SUBJECT: PLANS AND PROPOSAL ADDENDUMS
PROJECT: STP 2023 (675)MM CONTROL: 1433-02-044
COUNTY: COMAL
LETTING: 05/04/2023
REFERENCE NO: 0419

PROPOSAL ADDENDUMS

DESCRIPTION OF ABOVE CHANGES
(INCLUDING PLANS SHEET CHANGES)

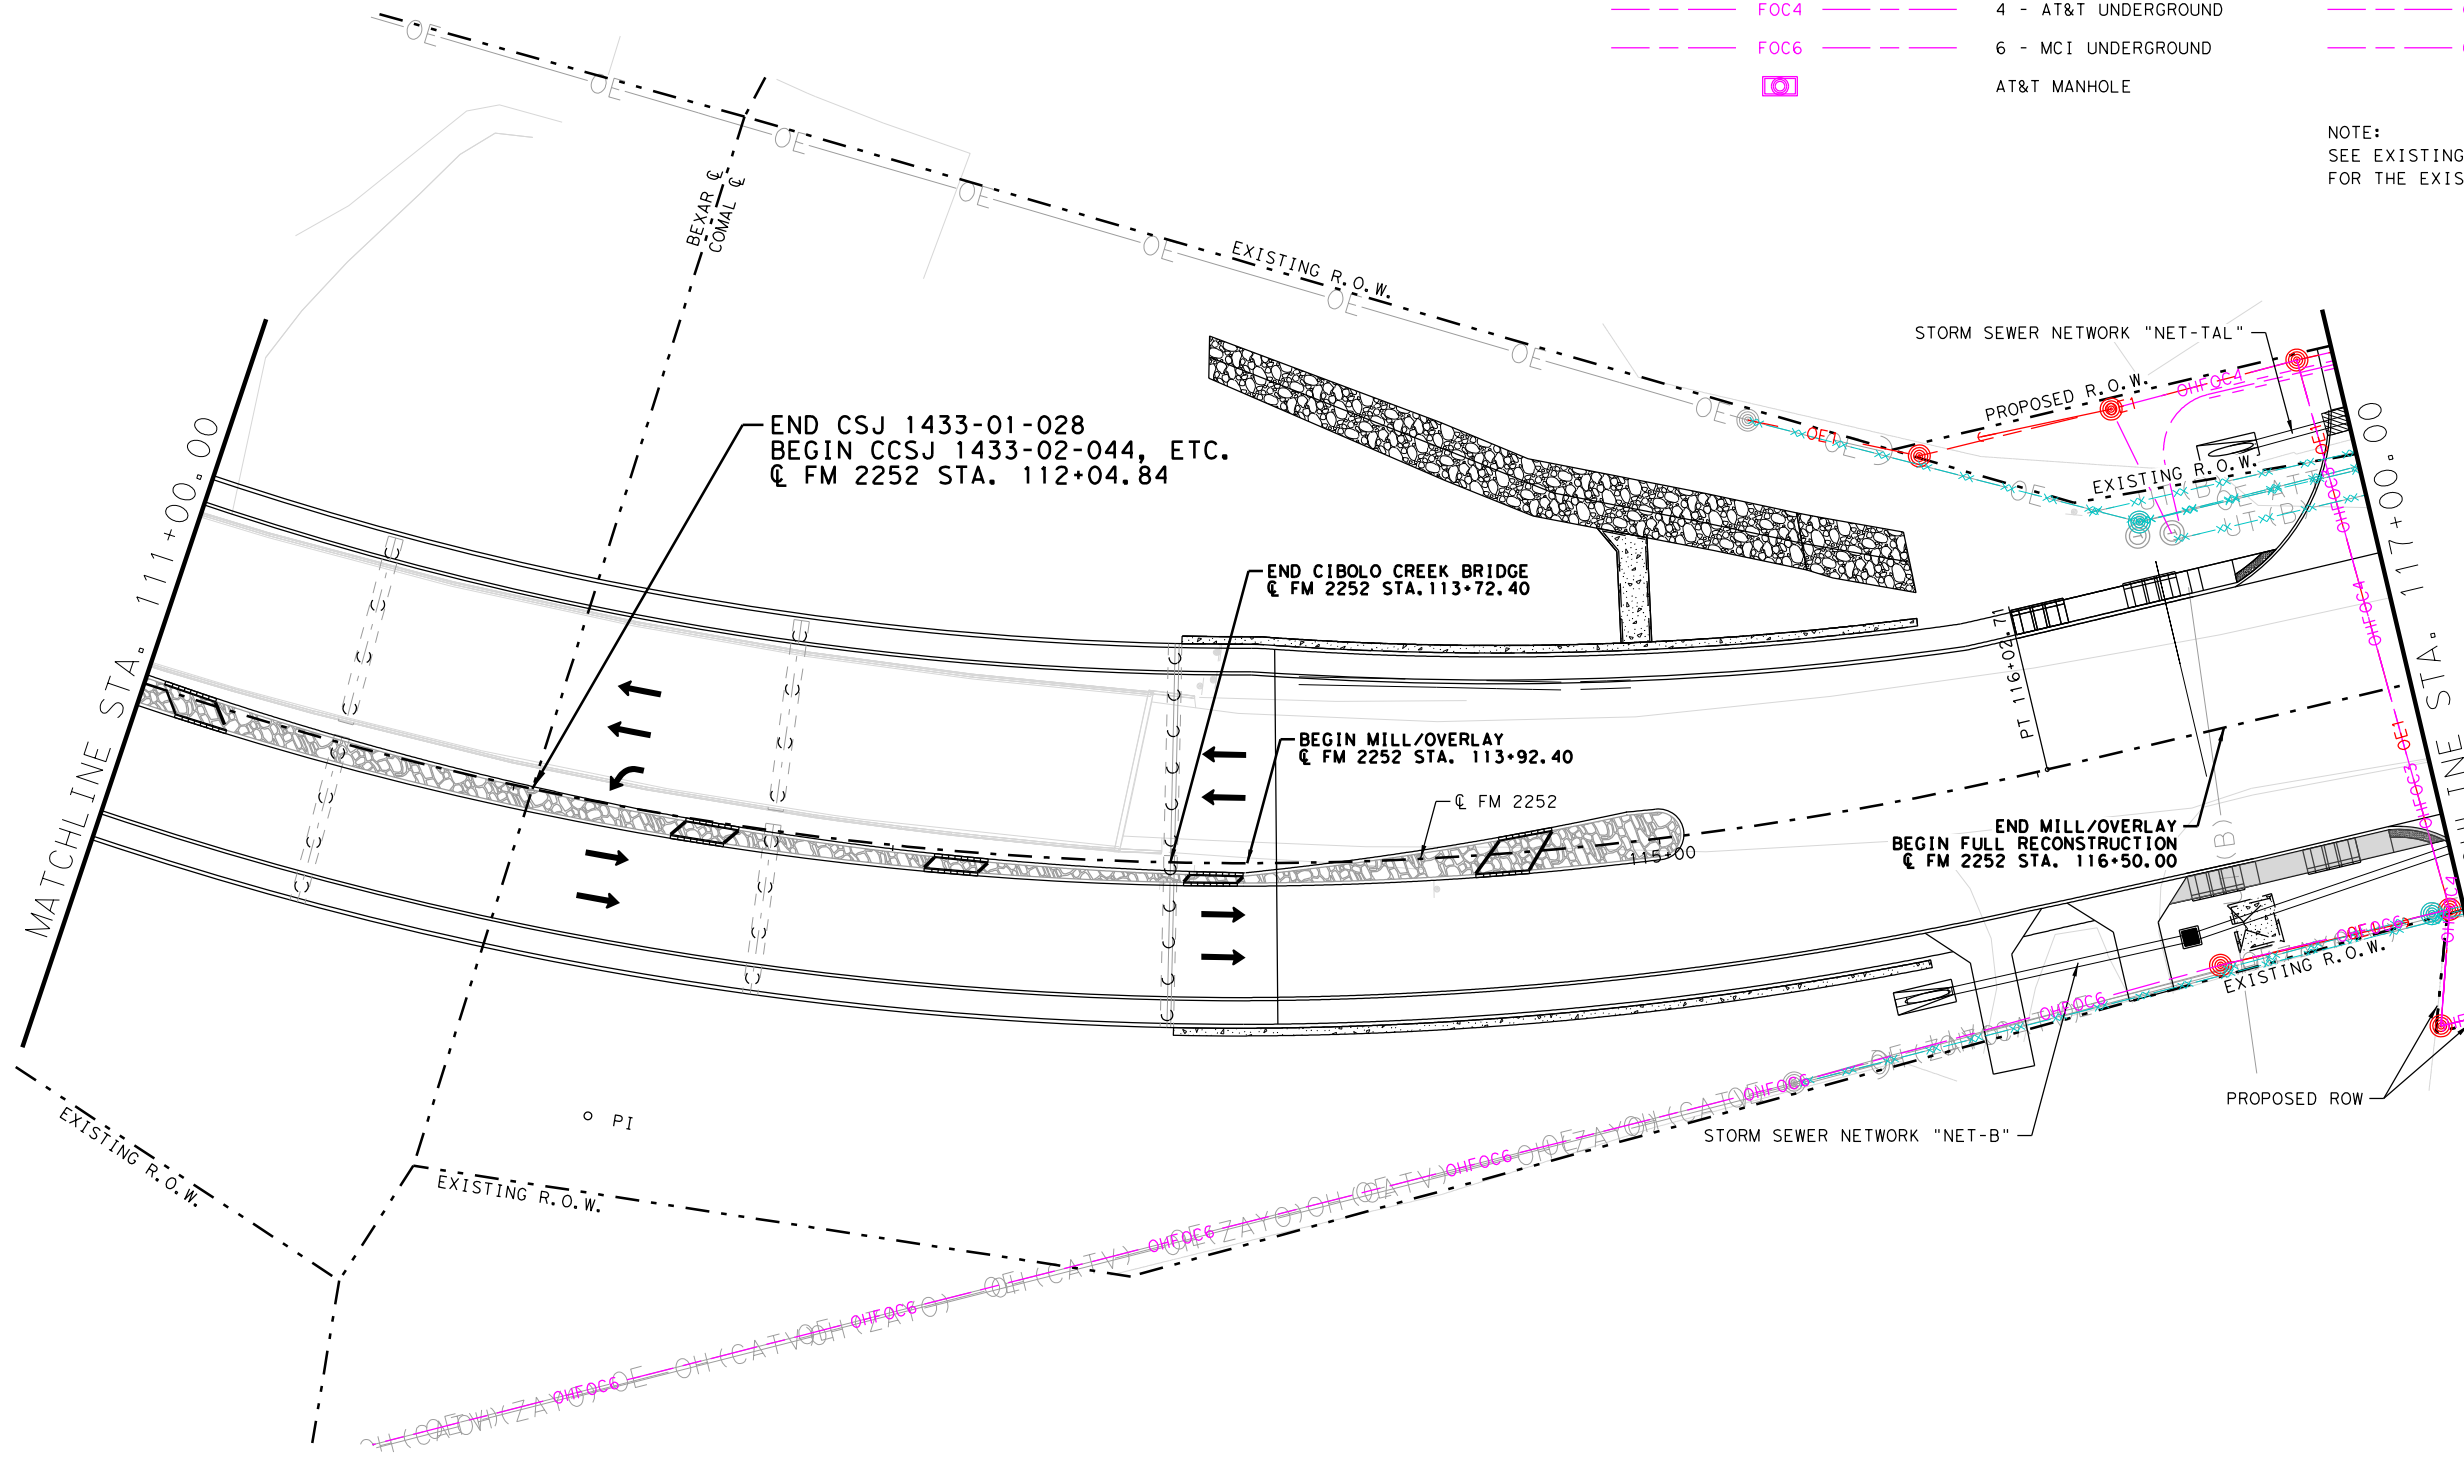
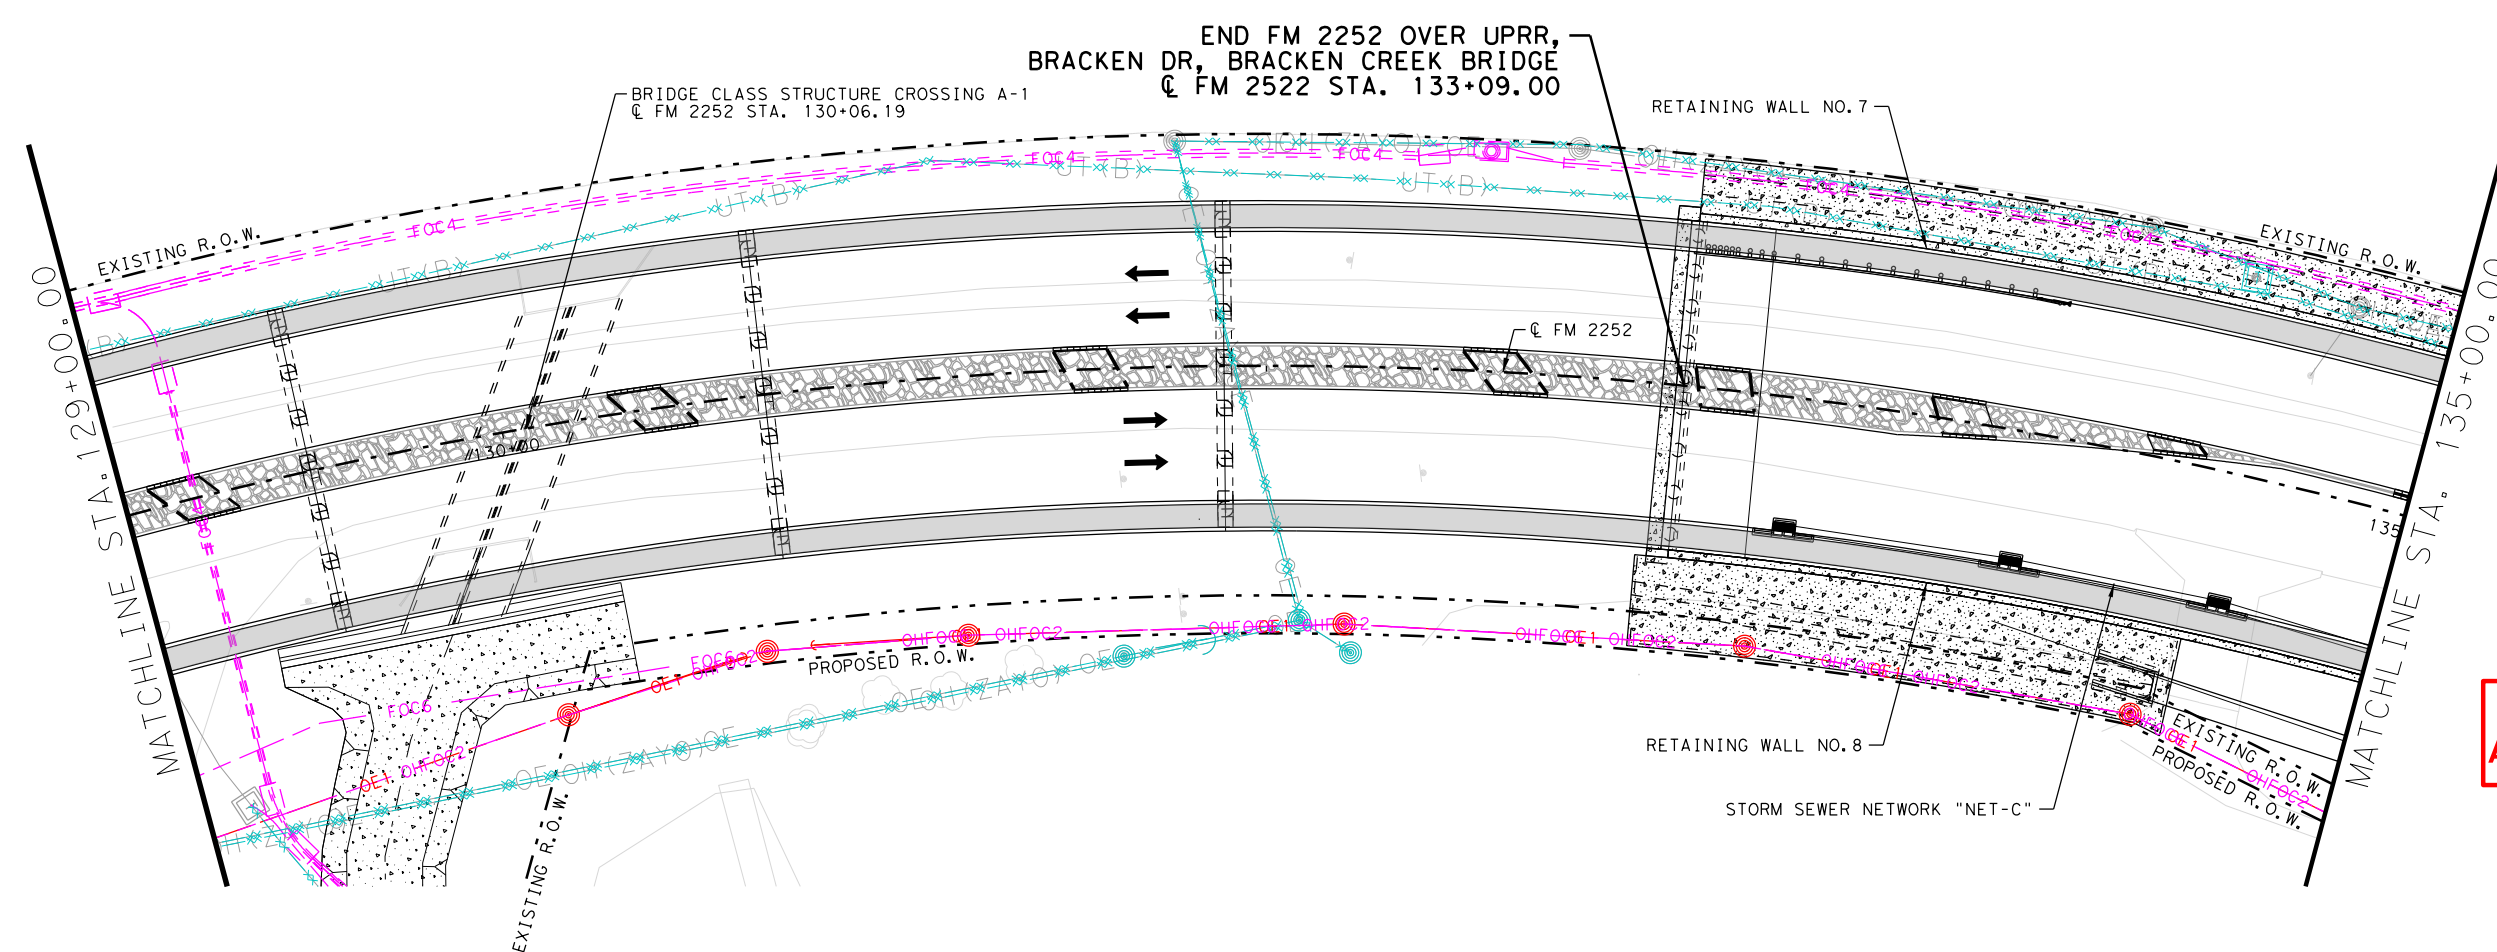
SHEETS 1330-1365: UPDATED UTILITY PLANS SHEETS LAYOUTS WITH CURRENT GAS
